<b>Docket Number:</b>	09-AFC-07C
<b>Project Title:</b>	Palen Solar Power Project - Compliance
<b>TN #:</b>	202480
<b>Document Title:</b>	Energy Commission Staff Supplemental Staff Assessment and Testimony
<b>Description:</b>	N/A
<b>Filer:</b>	Alicia Campos
<b>Organization:</b>	California Energy Commission
<b>Submitter Role:</b>	Commission Staff
<b>Submission Date:</b>	6/23/2014 4:06:56 PM
<b>Docketed Date:</b>	6/23/2014

**RE: ENERGY COMMISSION STAFF SUPPLEMENTAL STAFF ASSESSMENT  
AND TESTIMONY PALEN SOLAR ELECTRIC GENERATING SYSTEM  
DOCKET NO. (09-AFC-7C)**

**ENERGY COMMISSION STAFF SUPPLEMENTAL TESTIMONY**

**Figure 1**

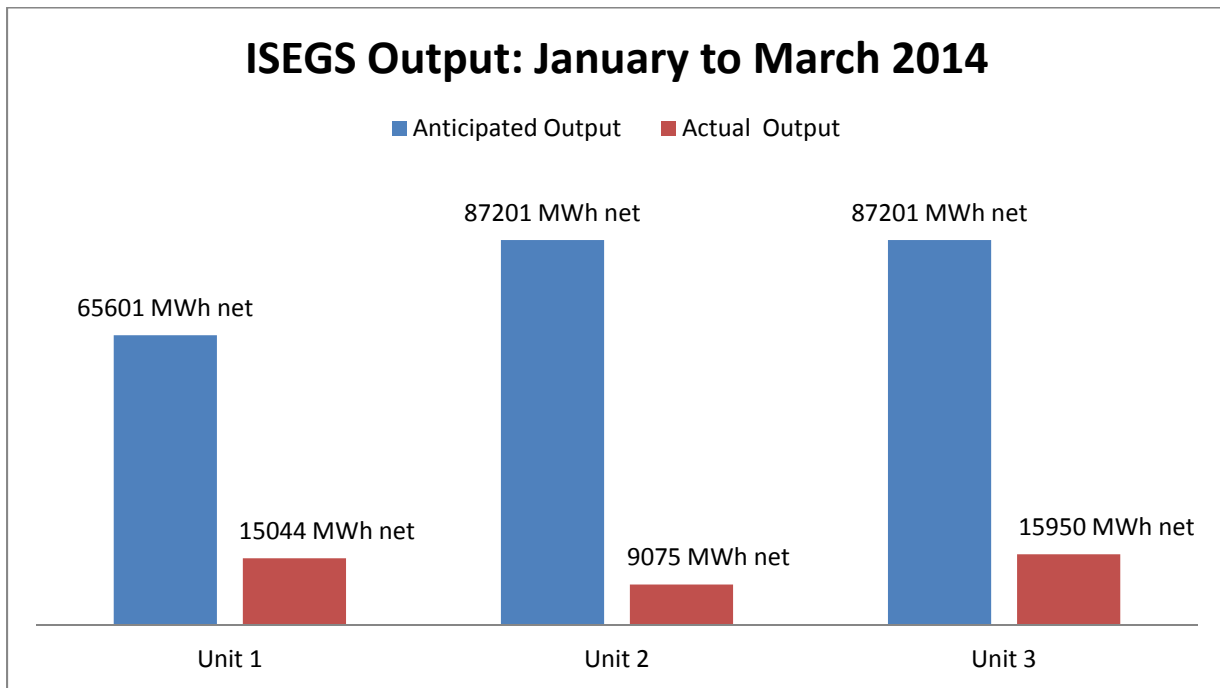
The location and intensity of the flux field is another important factor not considered in the monitoring data. Figure 1 depicts the operational data of the ISEGS project from January through March, 2014. From January to March, 2014, the facility ran at less than 20 percent of full capacity. It is unknown what the distribution or intensity of the flux field was during this period; however, since the project does not defocus mirrors based on operational constraints, heliostats would have been positioned in standby zones.

When the project is in standby it still concentrates flux to dangerous levels, even when the project is not operating, or running at less than full capacity. The avian data provided needs to be correlated with operational data to provide accurate estimates of the project operating at full capacity. Staff understands that the ISEGS monitoring report will be correlated with the operational data. This data cannot be expected to predict outcomes at the PSEGS; not only because of this factor, but because of the geographic differences, the presence of a defined avian migration route, the higher towers and larger project site.

**Photo 2.** Photo of the ISEGS site taken from the north. From left to right: Tower 3; Tower 2, not in operation; and Tower 1. The photographer's position in relation to heliostat position and orientation results in no DSRH from Tower 3, but strong DSRH from Tower 1 which causes disability glare.

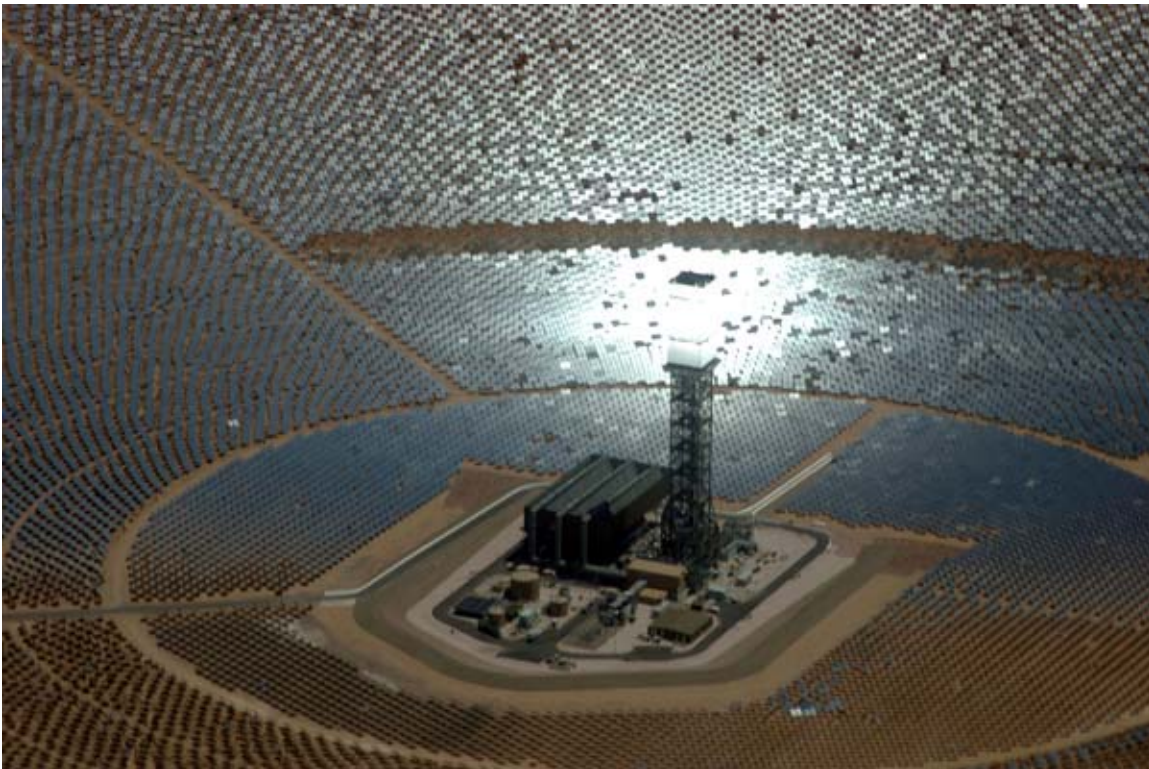
Photo 2 shows all three towers when viewed at a distance of approximately 11 to 12 miles to the north at an altitude of approximately 11,000 to 12,000 feet MSL. The amount of glare from the different towers' heliostat fields differs depending on the photographer's position relative to the heliostats. For example, the viewpoint to Tower 3 is just outside of the direct solar reflections from the heliostats (DSRH) produced by Tower 3's heliostats in the standby position. The periphery of Tower 3's heliostat field reflects the blue sky while the heliostats closer in visual alignment with the tower produce brighter reflections, as these heliostats are reflecting the brighter sky region in closer proximity to the sun. However, no DSRH are visible as none of the heliostats are directly reflecting the sun at the observer. The tower itself has its standard glow and the ring of reflections produced by heliostats in the standby position (standby ring) is not visible. In general, this is a situation not producing disability glare. A variety of bright individual heliostats can be seen which are apparently out of alignment, with one (to the right of the tower) very close to producing a DSRH event.

However, as shown in Photo 2, the photographer is situated so that Tower 1's standby ring is visible, with the heliostats flanking the left and right side of the tower producing exceptionally bright DSRH events in a steady state manner. The position of the photographer in relation to the position and orientation of the heliostats results in disability glare to the viewer. Although the standby ring circumscribes the tower (much like a doughnut shape with the tower as the hole in the middle) it appears that the glare is emanating from the left and right portions of the ring. This is because the line of sight through the ring (the doughnut) has the greatest density on the sides and the greatest number of heliostats producing DSRH events. The glare from the tower under these conditions is overwhelmed by the standby ring brightness and often is not even visible through the standby ring glare.

**Photo 3.** (ISEGS) *Example of line of sight geometry to Tower 3 outside of the DSRH projections of the standby ring. The photo was taken from the west.*

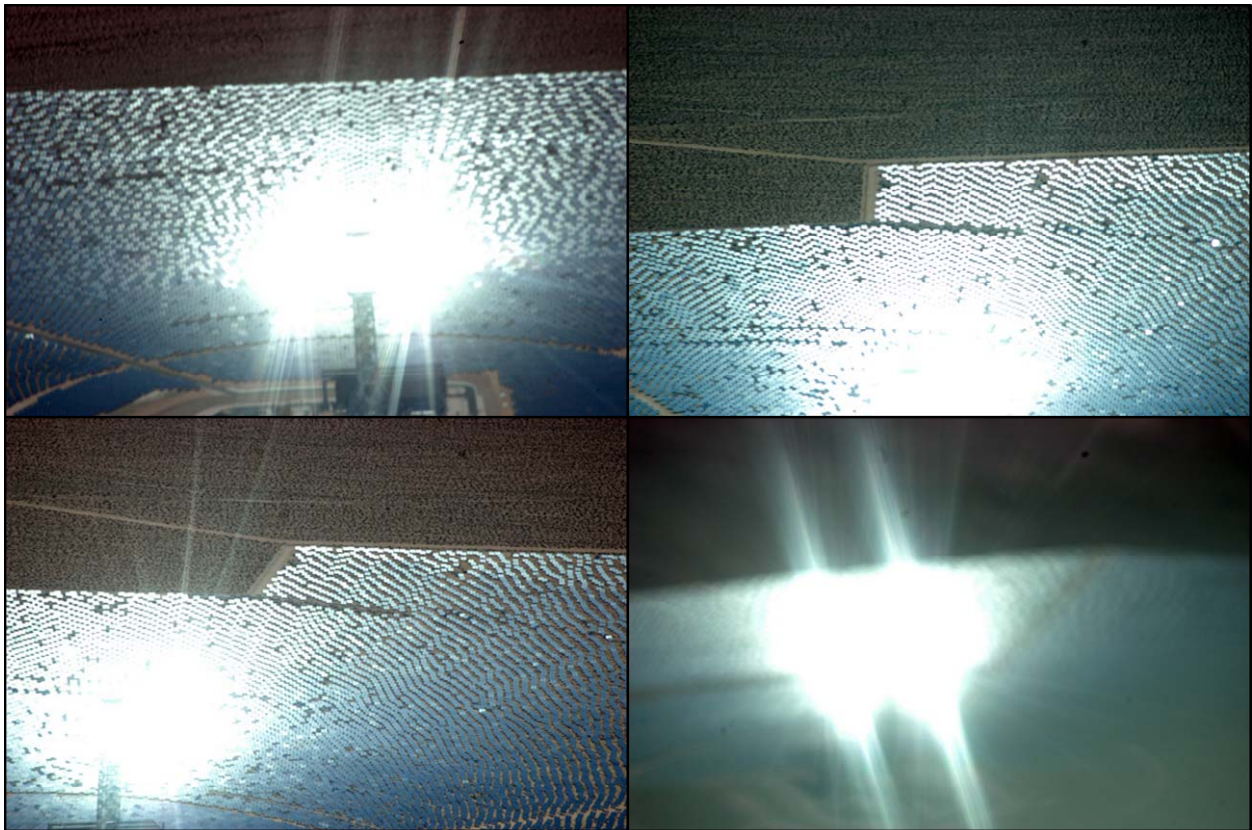
As staff circled the ISEGS heliostat field, they found that the glare from certain angles was acceptable. An example of this is shown in Photo 3, where the line of sight to the tower is outside of the standby ring projection. The glow of the tower receiver together with the heliostats' reflections of the sky in proximity to the sun is at acceptable levels and is not producing any DSRH event. Note that there are a number of heliostats that appear to be in unique positions, perhaps out of alignment. Also, there is a band of heliostats in some other position, perhaps in stow, a cleaning position, or simply off-line.
